PM7366 FREEDM-8

REVISION D AND E DEVICE ERRATA

Issue 7: November 2001

Figure 2.1: Receive Packet Descriptor.

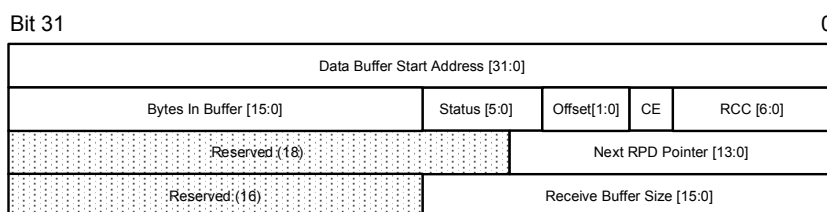
When ALL of the following conditions are met:

1. The offset[1:0] field of a Receive Packet Descriptor (RPD) is non-zero.
2. The STRIP bit of register "**0x204 RHDL Indirect Channel Data Register #1**" is logic one.
3. The incoming packet payload is smaller than the FCS field (2 bytes for CRC-CCITT or 4 bytes for CRC-32).

The value in the "Bytes in Buffer [15:0]" field of the RPD can be underflowed. That is, this field will contain a negative value. If this field is interpreted as an unsigned integer, the content of the buffer can be erroneously interpreted as a very large number.

If the "Bytes in Buffer" field is interpreted as a very large number, the driver software may attempt to read data from outside of the allocated buffer space.

1. If the Offset[1:0] bits of RPD are set to zero, this problem will not occur.
2. If the STRIP field of "**0x204 RHDL Indirect Channel Data Register #1**" is set to zero, this problem will not occur.
3. If the buffer size is not larger than 32K Bytes, the most significant bit of the "Byte in Buffer" field can be used as a sign bit. The device software should discard RPDs that contain a negative "Bytes in Buffer" value.
4. For every RPD, the driver software can compare the "Bytes in Buffer[15:0]" field to ensure that it is smaller than or equal to "Receive Buffer Size[15:0]".

Figure 2.2: PCI Interface Timing

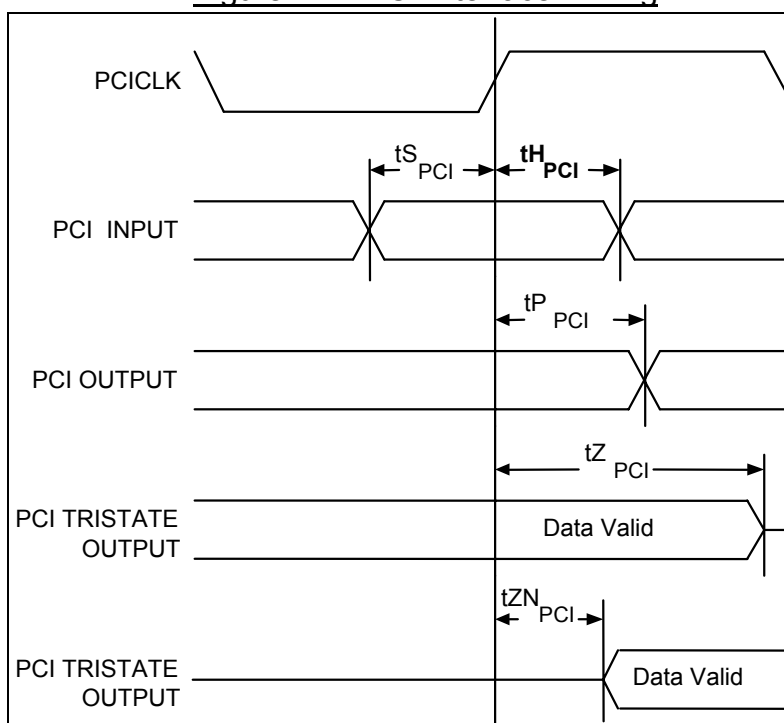
PCI Input and Bi-directional signals require a minimum hold time ($t_{H_{PCI}}$) of 1 ns with respect to PCICLK.

If the clock skew is not kept within the above limit, FREEDM-8 may operate incorrectly.

The PCI 2.1 specification requires PCI outputs to have a minimum 2 ns propagation delay. The clock skew between FREEDM-8 and other PCI devices in a system must therefore be kept below 1 ns to ensure correct operation.
